RE: URBAN DESIGN COMMISSION SUBMITTAL – REQUESTING INITIAL APPROVAL
EDGEWATER HOTEL REDEVELOPMENT, 666 WISCONSIN AVENUE, MADISON, WISCONSIN

EDGEWATER REDEVELOPMENT

REVISED SUBMITTAL PACKAGE

**RE: UPDATED PUD SUBMITTAL PACKAGE FOR
EDGEWATER HOTEL REDEVELOPMENT, 666 WISCONSIN AVENUE, MADISON, WI 53703**

Figure 1.3 Previous Lakefront Elevation as Compared to Revised Lakefront Elevation

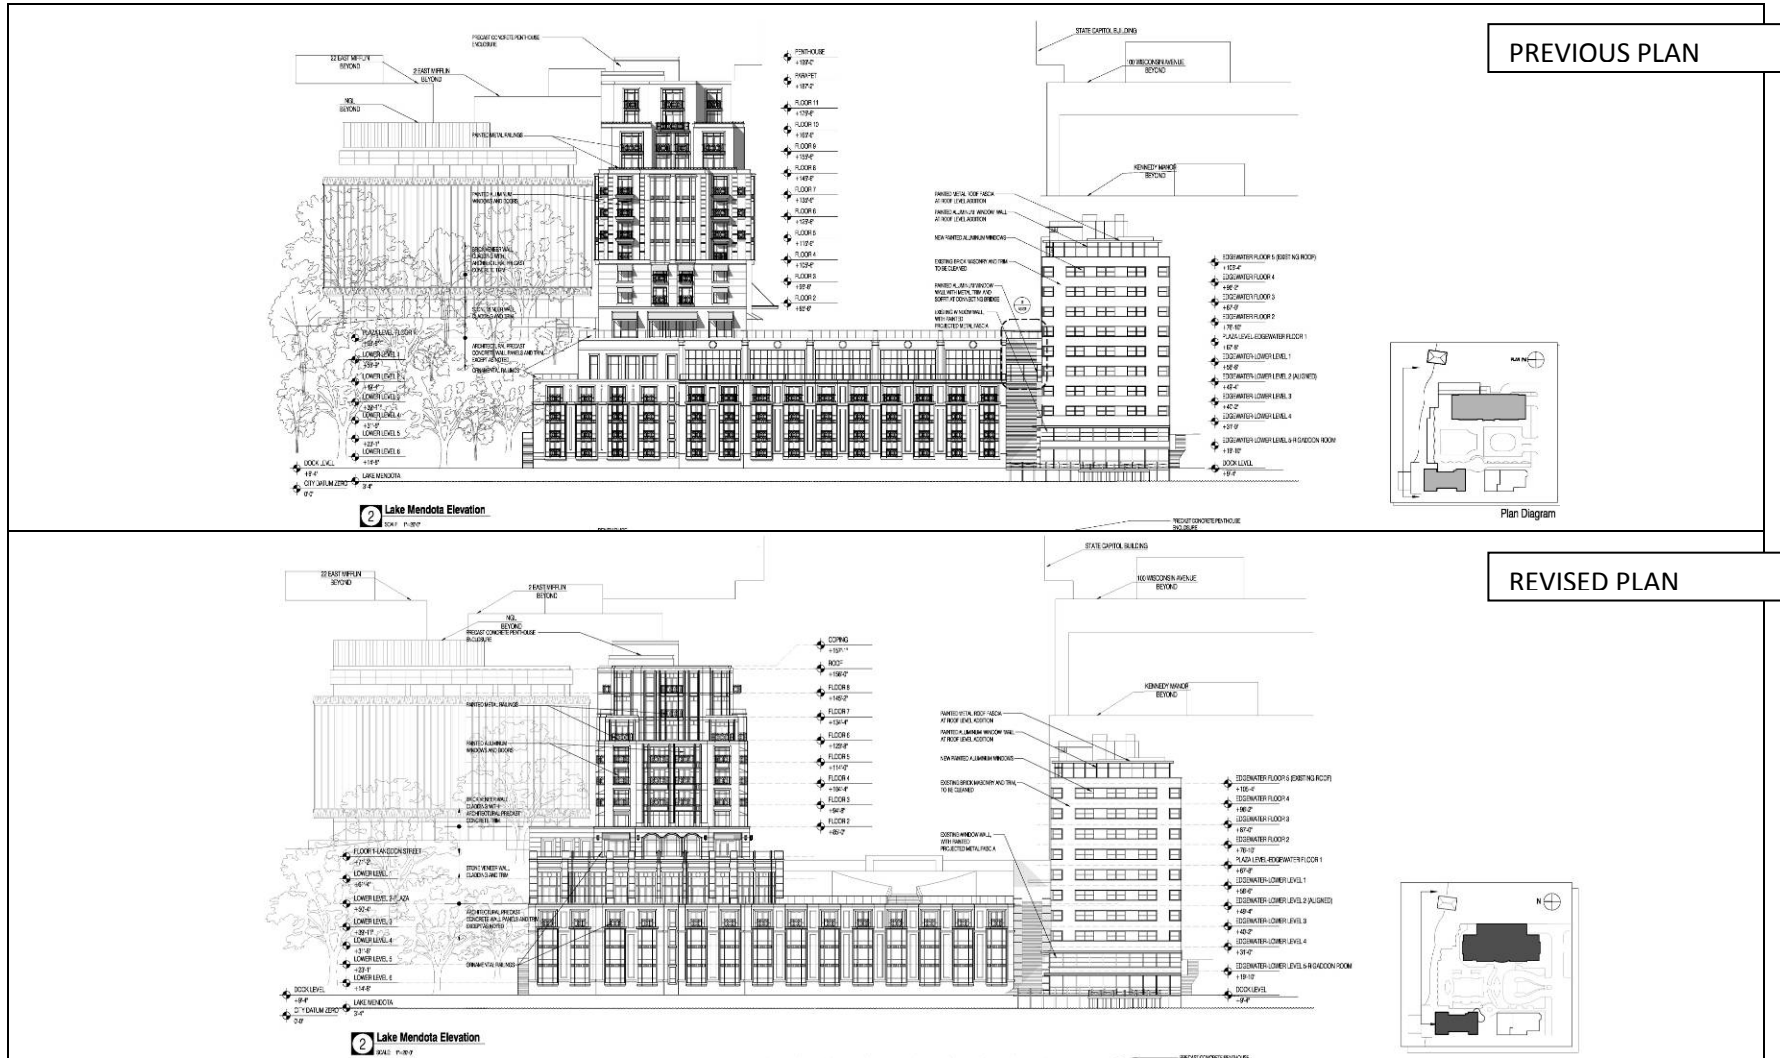
The proposed expansion tower has been reduced by 3 stories and a total of 30 feet in height. The last occupied floor of the expansion tower has been lowered from 187'-2" (the Capitol Height Limit) to 157'-1" which is equivalent to the height of the last occupied floor of the adjacent National Guardian Life building. Figure 1.3 illustrates the height of the proposed tower in relation to the previously proposed design.

Figure 1.4 Summary of Existing Building

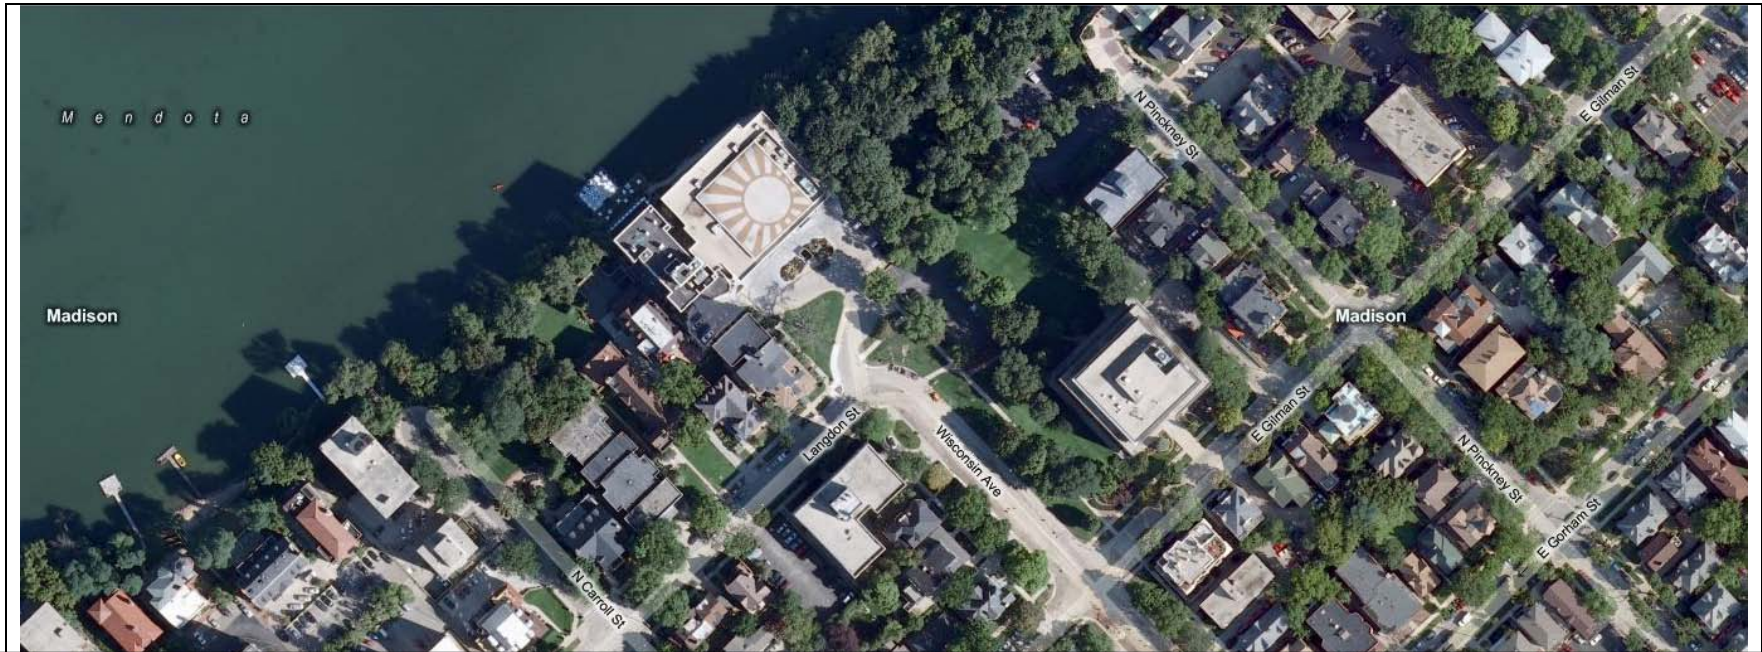
The proposed expansion has been designed so that the last occupied floor is equal in height to the National Guardian Life Building. Additionally, the top two-floors of the building have been set back from the lower floors and this setback has been established to be generally consistent with the height of Kennedy Manor, which sits on the opposite street corner from the proposed expansion. Figure 1.3 illustrates the relationship of height of the building in the revised plan as compared to these surrounding structures. Figure 1.4 provides an aerial of the site and images of the surrounding buildings.

Figure 1.5 Sectional Comparison Existing vs. Revised

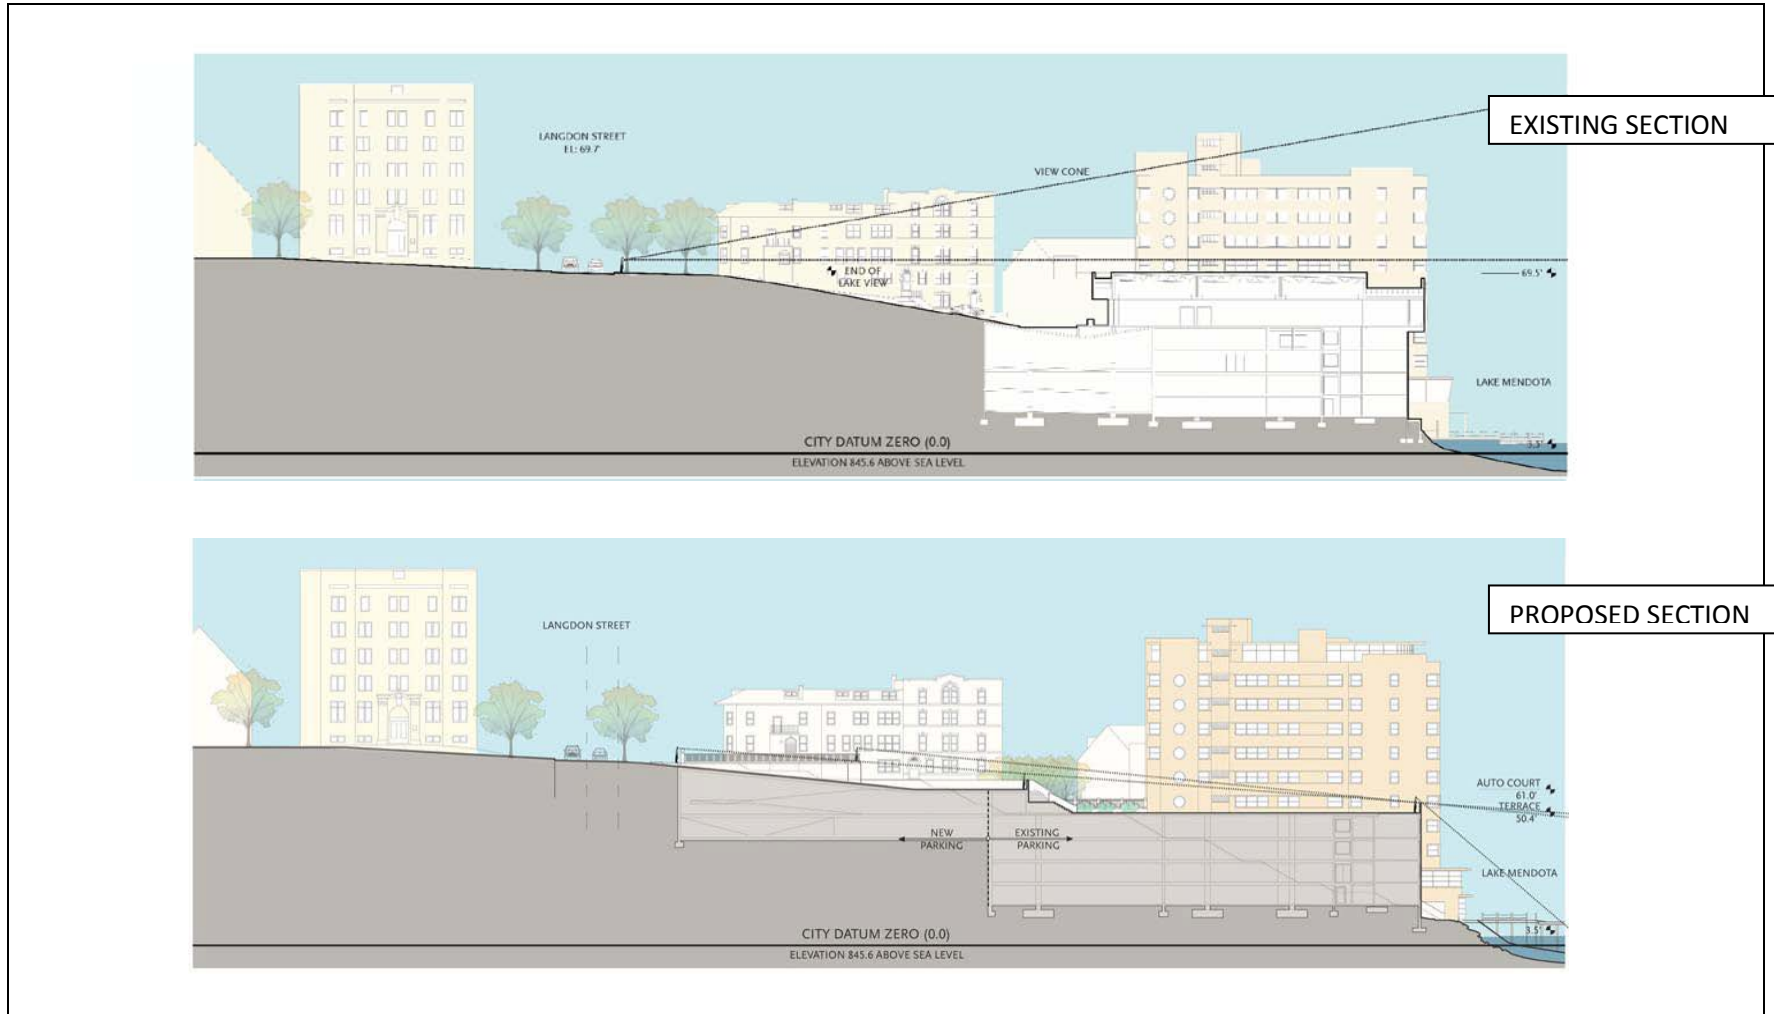
Landmark has proposed to remove the top level (20+ feet) of height and 295,000 cubic feet of volume from the 1970's expansion which was built in the vacated Wisconsin Avenue right-of-way. This change will not only result in an enhanced terrace and public space at the water, but will also restore one of Madison's most important street-end views.

This change has significant impacts for the public view from the street to the lake and from the lake back to the State Capitol. Additionally, the removal of this existing structure will transform this corridor from a solid structure to an open, active public terrace at the lakefront. Figure 1.5 provides a sectional illustration of the existing and proposed conditions for the terrace.
